AFSC-TP-81-50

FINAL ENVIRONMENTAL  
IMPACT STATEMENT  
MX: BURIED TRENCH CONSTRUCTION  
AND TEST PROJECT

November, 1977

Figure 5. An oblique aerial view of the upper third of the proposed alignment of the long trench, as viewed from the east.

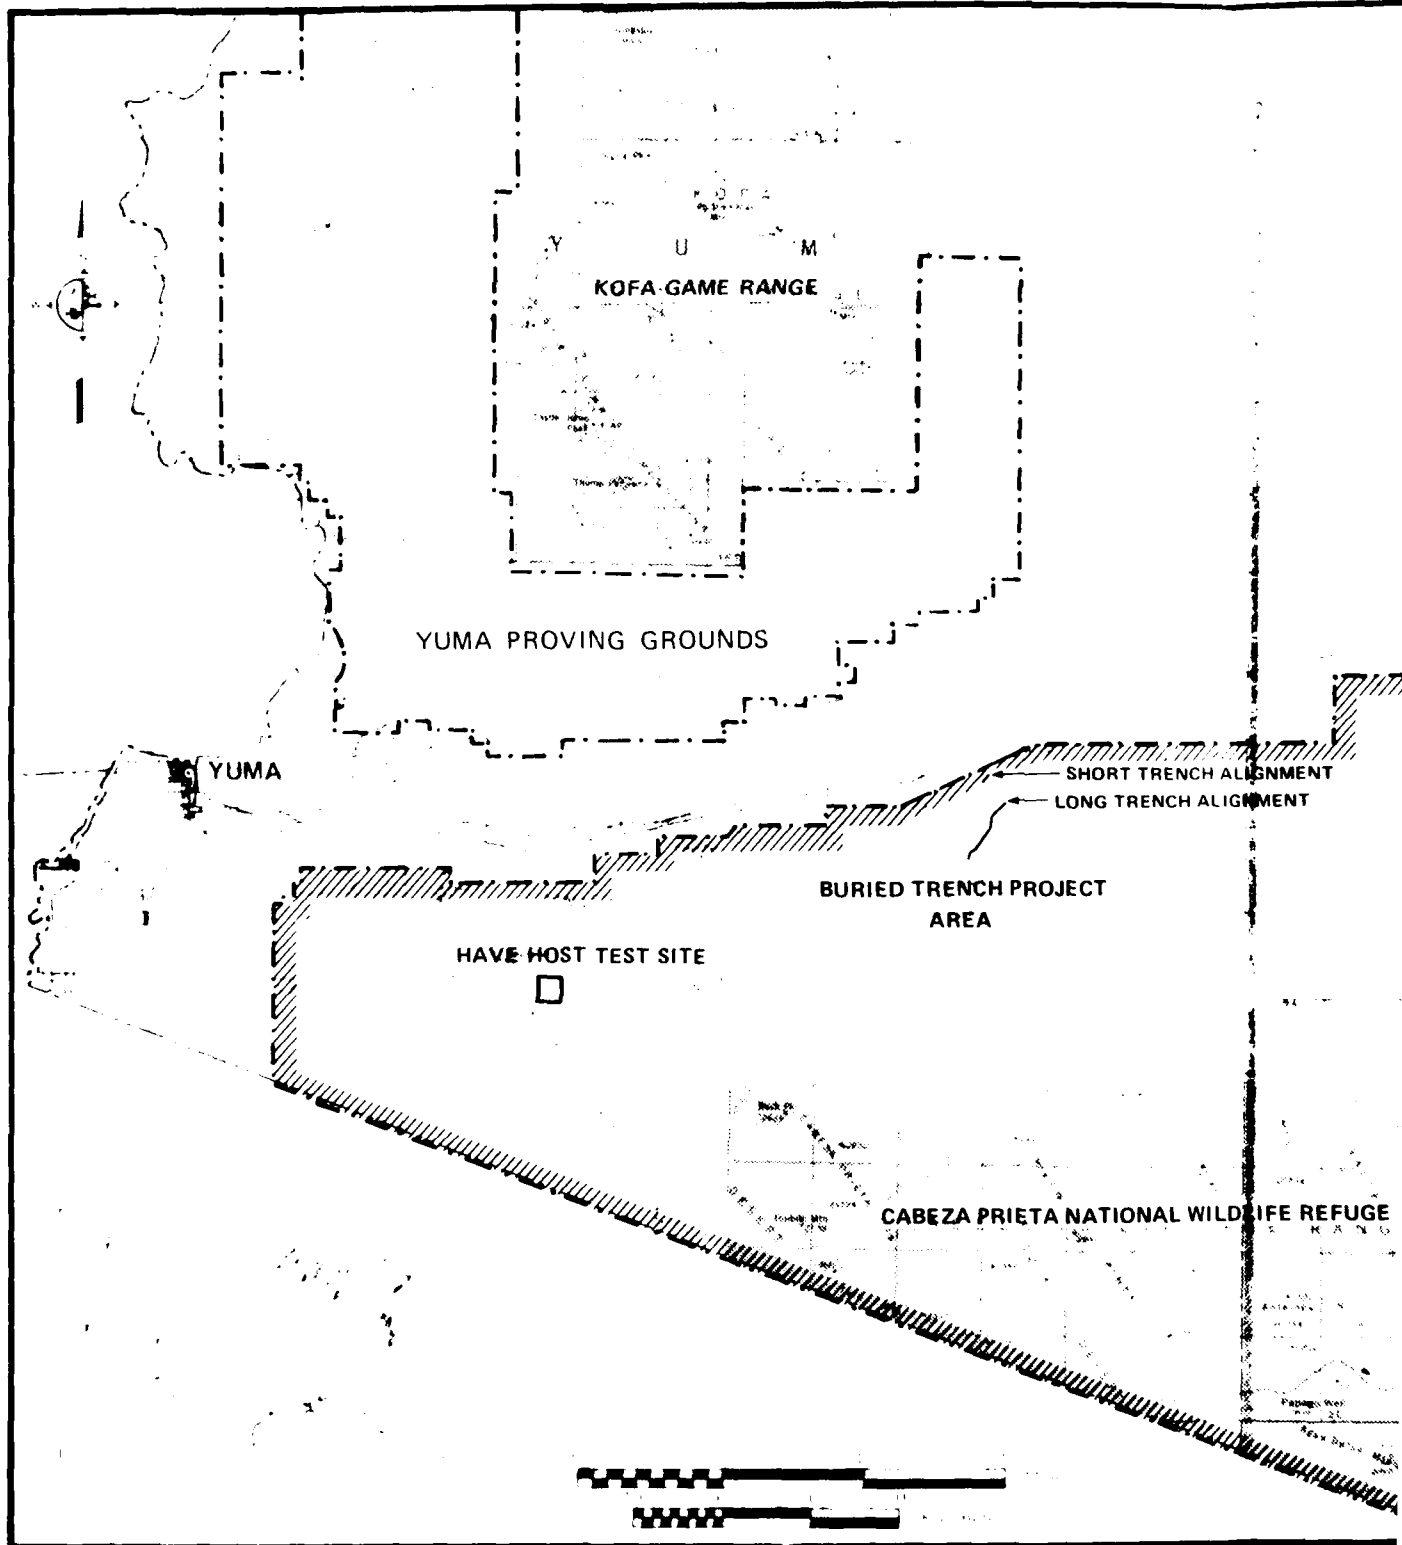
Figures 3 and 5: Should not the "Approximate Alignment of Long Trench" extend to the left edge of Figure 5? Such is indicated by comparison with the Field of View shown on Figure 3.

22. The angle of view shown on Figure 3 for Figure 5 is slightly more acute than it should be.
23. Compaction to 90 percent Proctor density is used to provide adequate support for the buried trench.
24. Care has been taken to minimize crossing of arroyos. All arroyos disturbed by construction will be restored to their preexisting condition when feasible, to prevent blocking of permanent drainage systems (see Sections 3.1.1, and 3.1.2, and 5.4).
25. Where areas of varnished desert pavement are disturbed during construction, the surface layer of rocks will be stockpiled and spread evenly over the surface following backfilling.
26. This has been corrected.

Figure 12. Support facility locations for project construction.

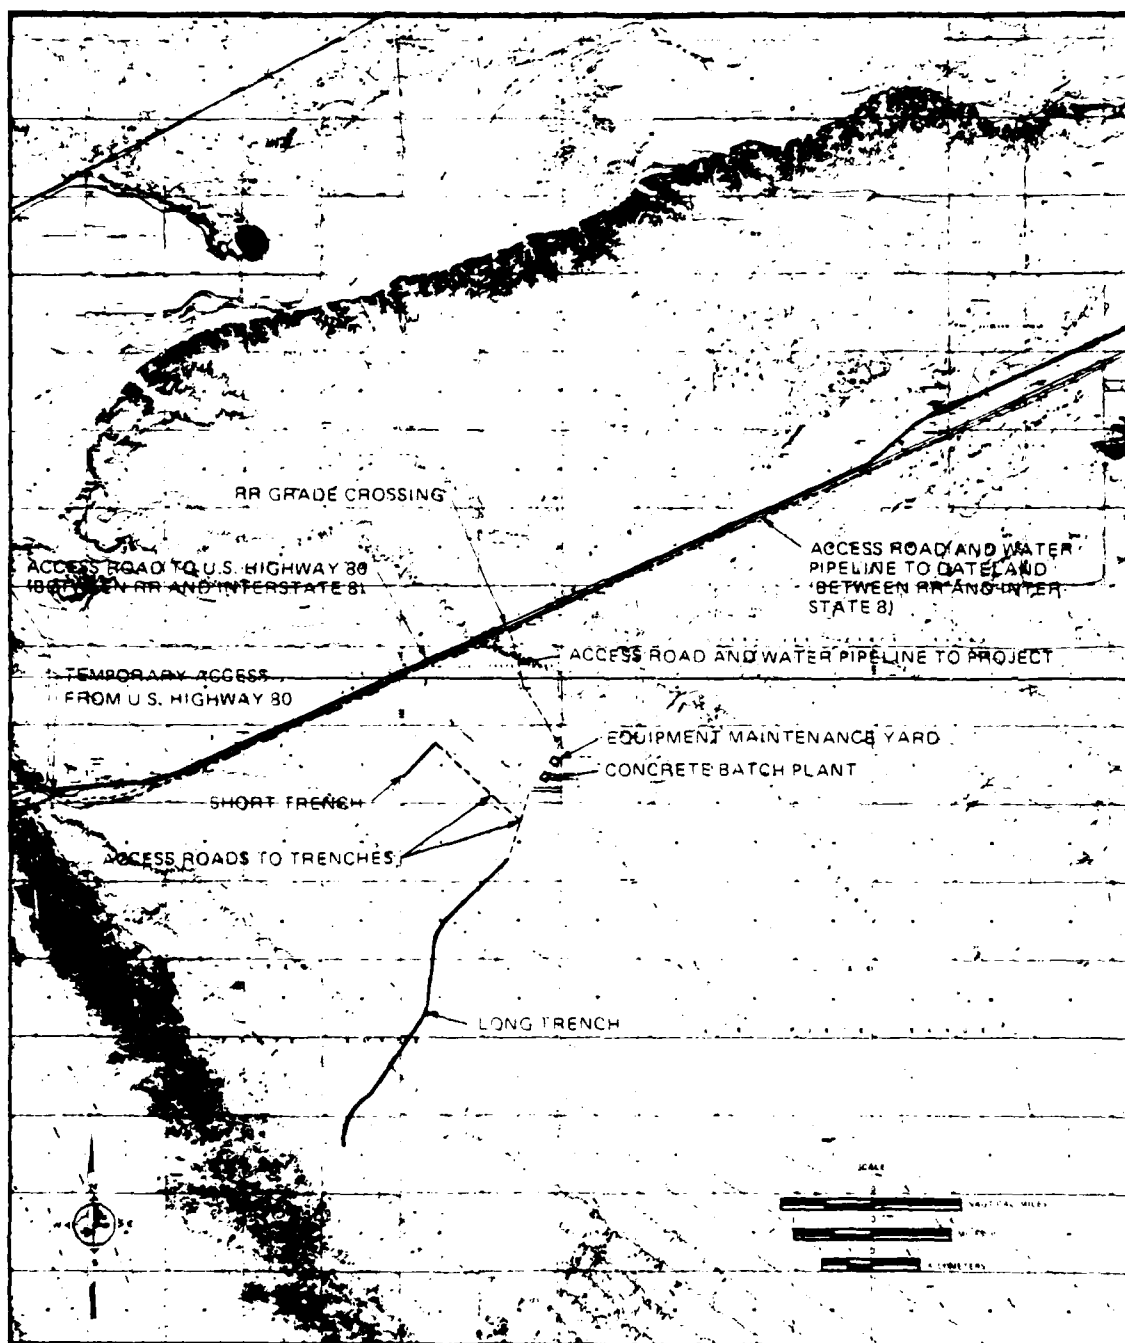
Figure 12, page 17, shows a slip-ramp off Interstate 8 providing  
truck access during construction. To avoid construction traffic  
interfering with interstate traffic, it is suggested that the point  
of access be moved to the east-bound ramp of the Mohawk Interchange  
as indicated on the enclosed diagram. This turnout has good visibility  
in both directions along with being a two-way road.

5. This suggestion has been incorporated in Section 1.1.6.1.

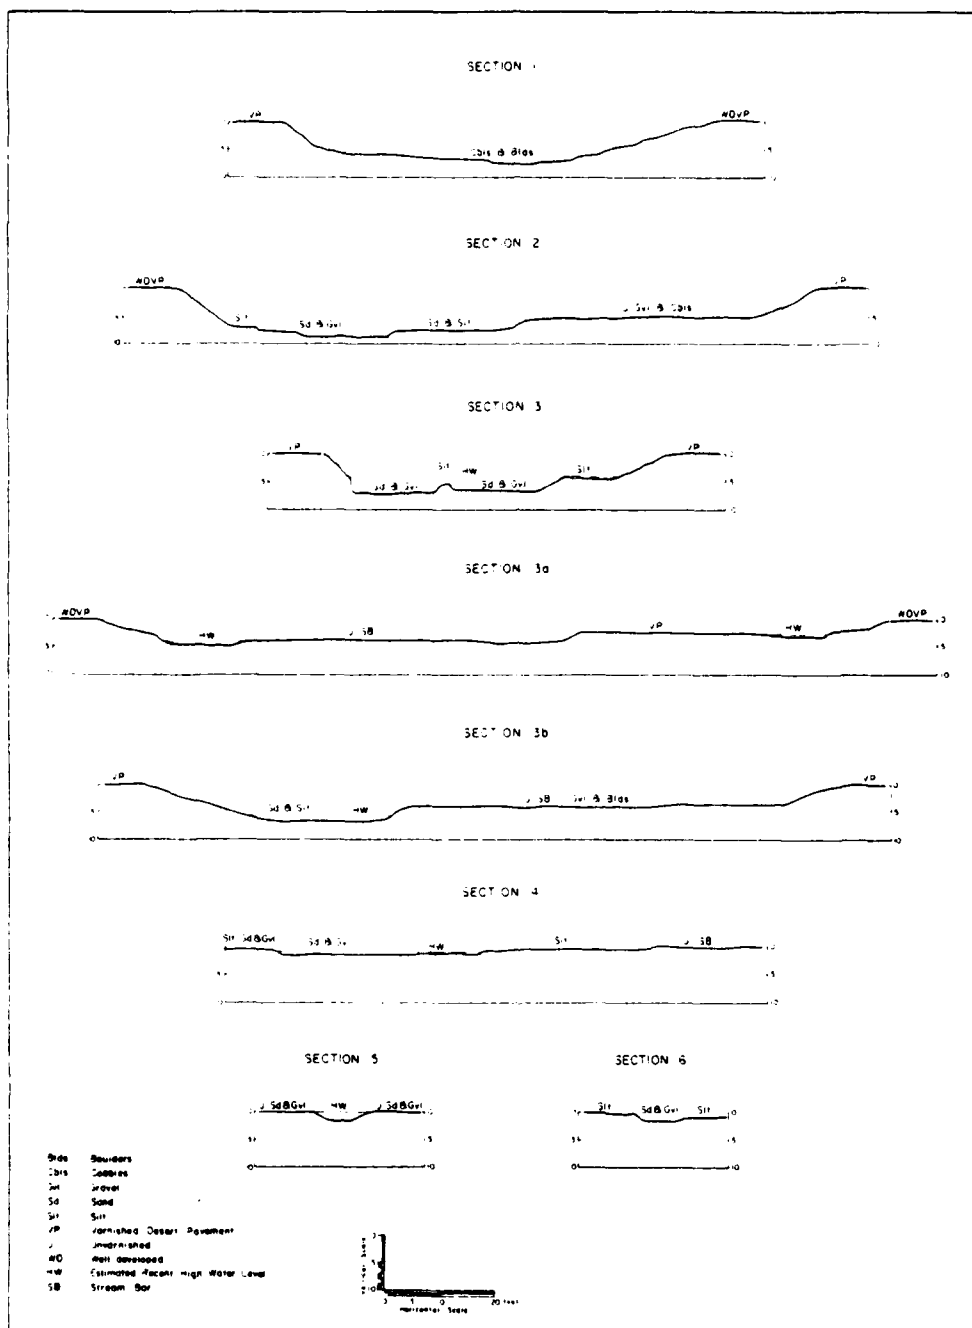
1.1.7.6): Reference should be made to the fact that the alignment has been carefully selected so as to make a minimal impact on arroyos. Figure 14 shows that only three such features are actually traversed by the alignment

However, Figure 14 also depicts near incidence of the alignment (possibly within the 100-m disturbed zone) to several other arroyos at or near measured channel cross sections 2, 3, 3a, 3b, 10, 15, and 19. Plans may have to include modification of the construction use of the proposed disturbed zone so as not to impact the near bank of the adjacent arroyo.
